2033 4TH AVENUE

DESIGN REVIEW MEETING

SDCI #3038668-LU /11 OCT 2022

Departure #1:

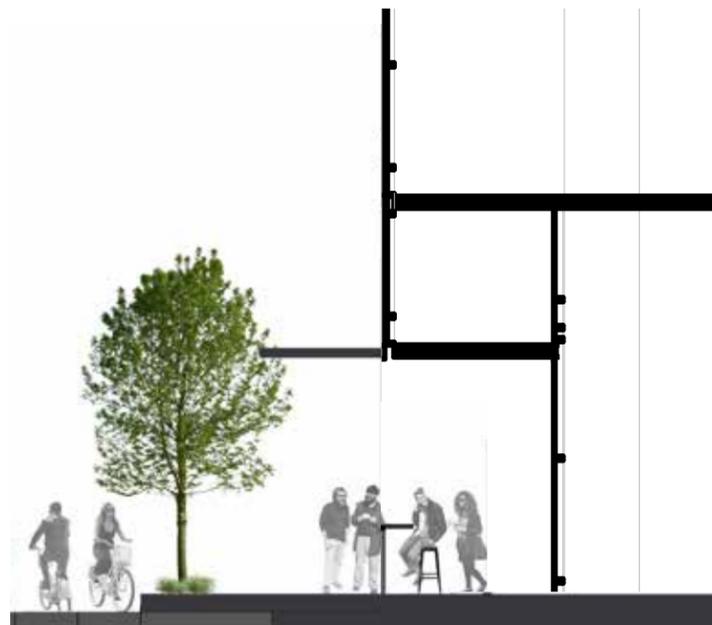
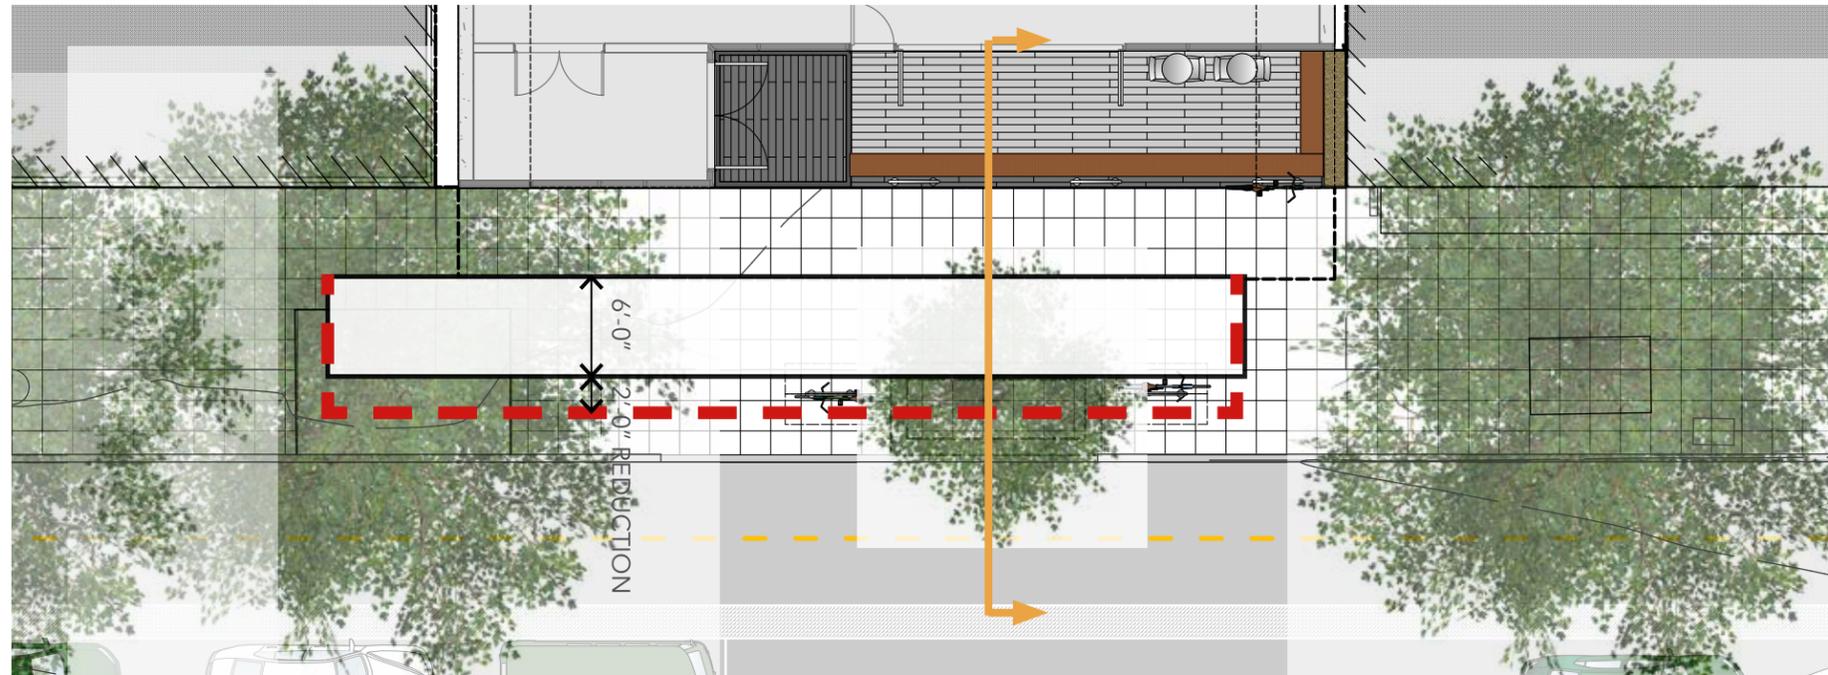
Setback at street level (SMC 23.49.056.b.2):

Facade setback limits:

A.1) if structure is >15-0 ft high, setback limit applies to the façade between 15-0 ft above the sidewalk and min. Façade height

B. Max area of all setbacks between street lot line & facade along each street frontage shall not exceed area derived by multiplying averaging factor by width of street front along the street.

Averaging factor is 5 on class I pedestrian streets.

C. Max. Width of any setback exceeding 15-0 ft depth from lot line shall not exceed 80-0 ft or 30% of the lot frontage on that street, whichever is less

Response: The setback is 9 ft deep x 45 ft long x 21 ft tall. This is to provide a larger outdoor seating area, along with the main entry. The higher notch at the street allows for more dramatic outdoor seating area - we are able to layer the ceiling plane to create outdoor 'rooms' - further distinguishing the main entry from the outdoor seating area. The opening behind the canopy would allow light to flow through while subtly dividing the space.

Departure #2:

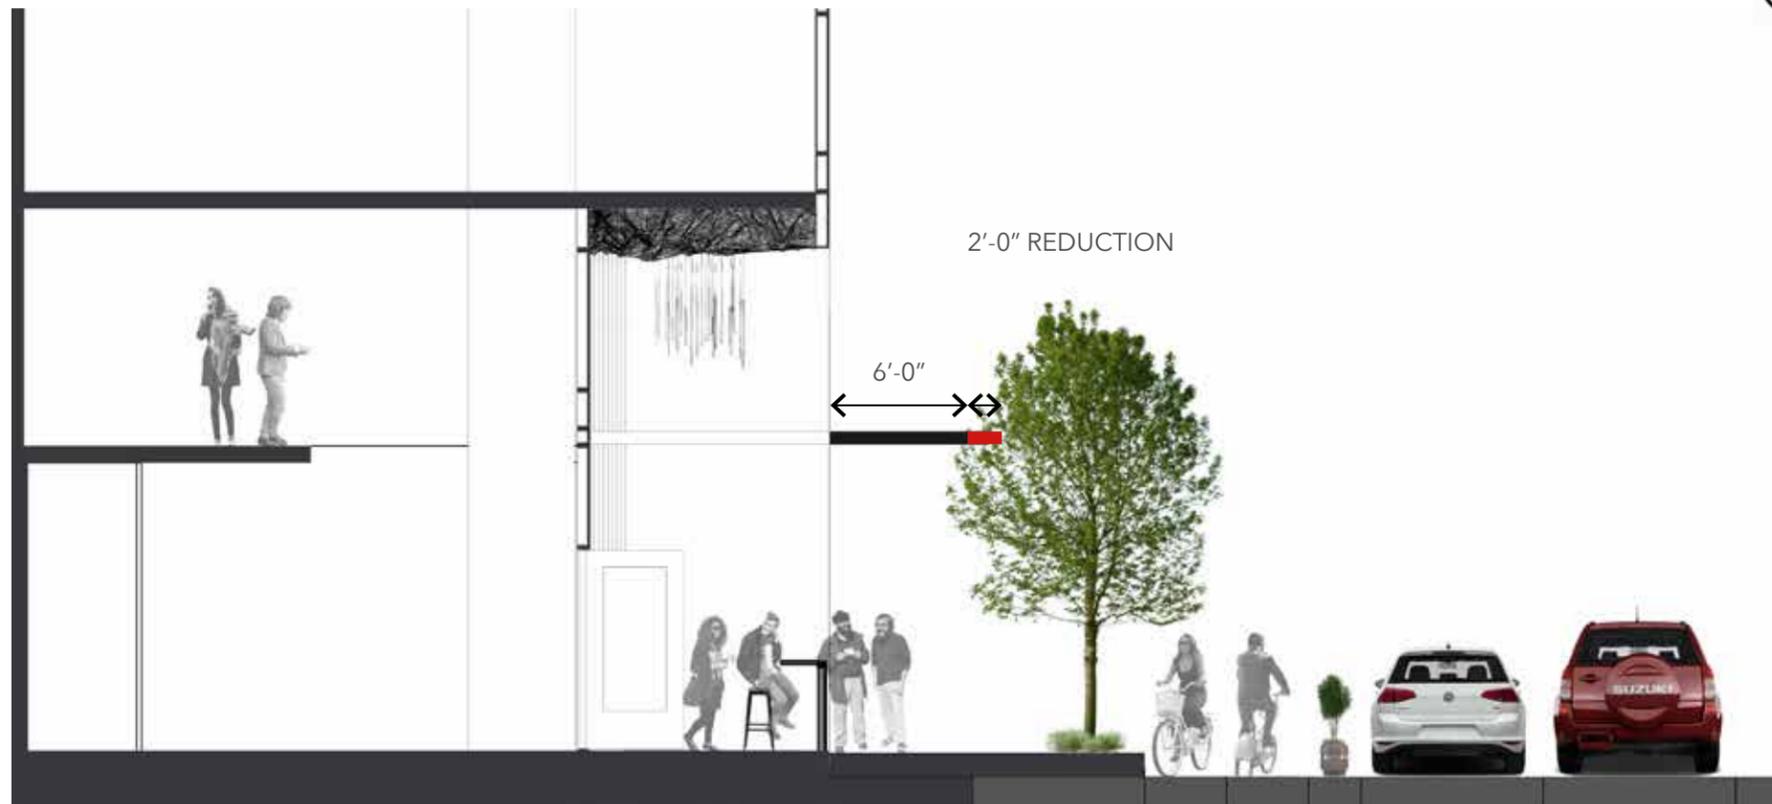
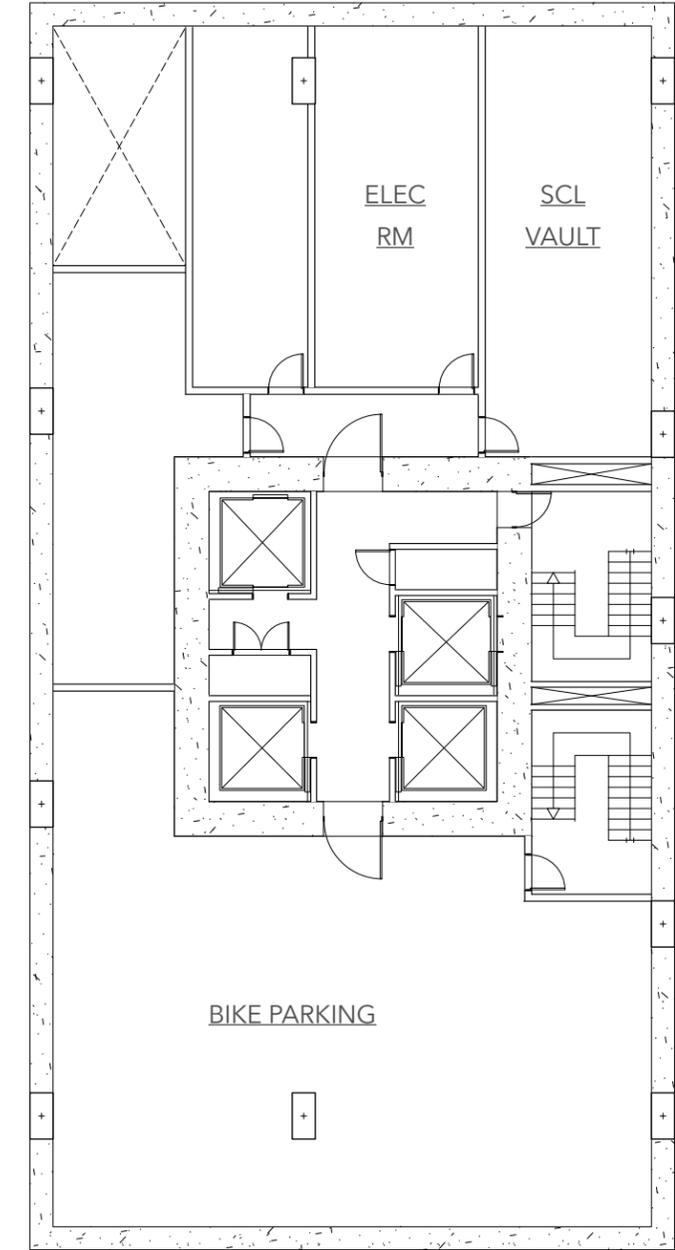
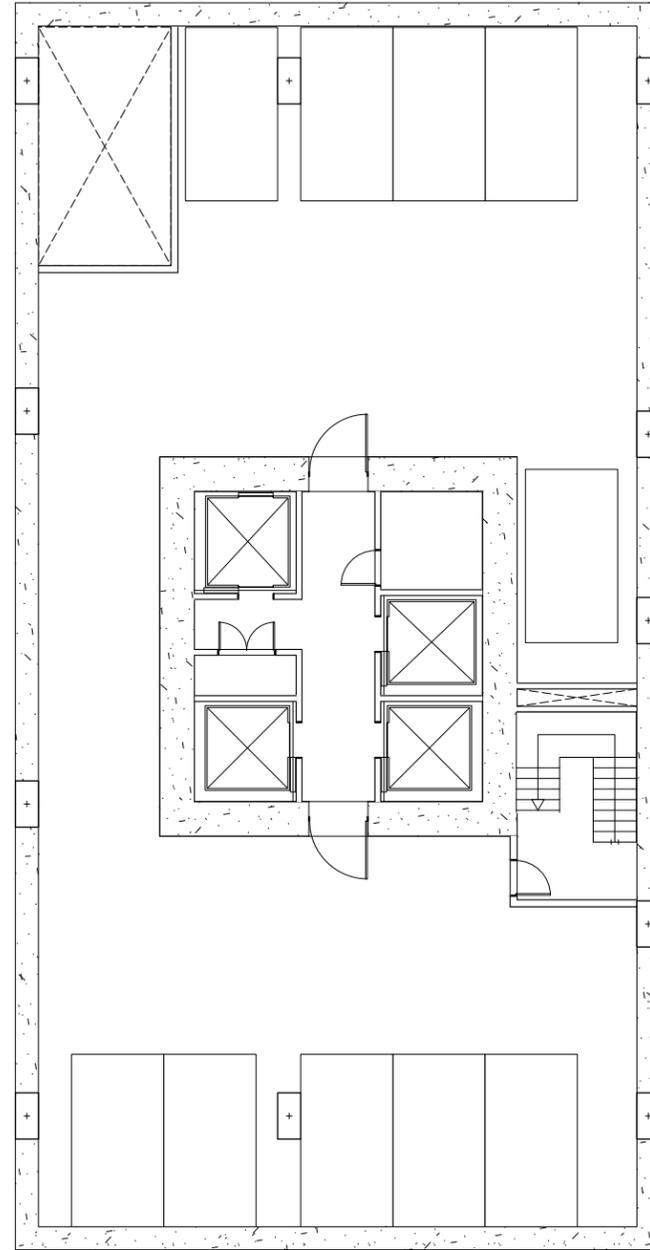
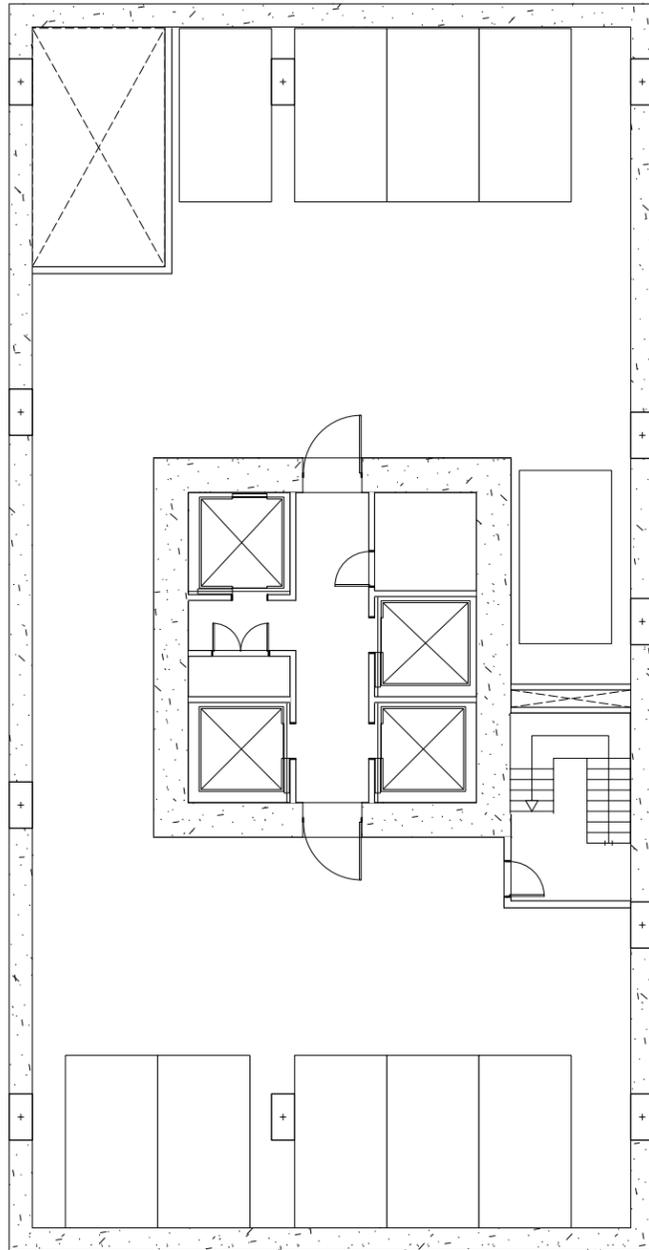
Overhead Weather Protection (SMC 23.49.018): The Code requires that overhead weather protection shall have a minimum dimension of eight (8) feet measured horizontally from the building wall or must extend to a line two (2) feet from the curb line, whichever is less.

The applicant is proposing to reduce the width of the overhead weather protection by 2 feet to reduce potential impacts to the existing street trees along 4th Ave.

The justification as stated is the desire to maintain healthy tree coverage along 4th Ave.

The Board indicated full support of the departure request for the reasons provided, as the departure has the potential to better meet the intent of Design Guidelines B-3.3. Pedestrian Amenities at the Ground Level, C-1.3. Street Level Articulation for Pedestrian Activity, C.4 Reinforce Building Entries, C.5 Encourage Overhead Weather Protection, D-1.1. Pedestrian Enhancements, C-5.A, Overhead Weather Protection Design Considerations.

Response: To help keep healthy tree coverage along 4th Ave we propose a 2-0 reduction in the width of the weather protection. The full depth would
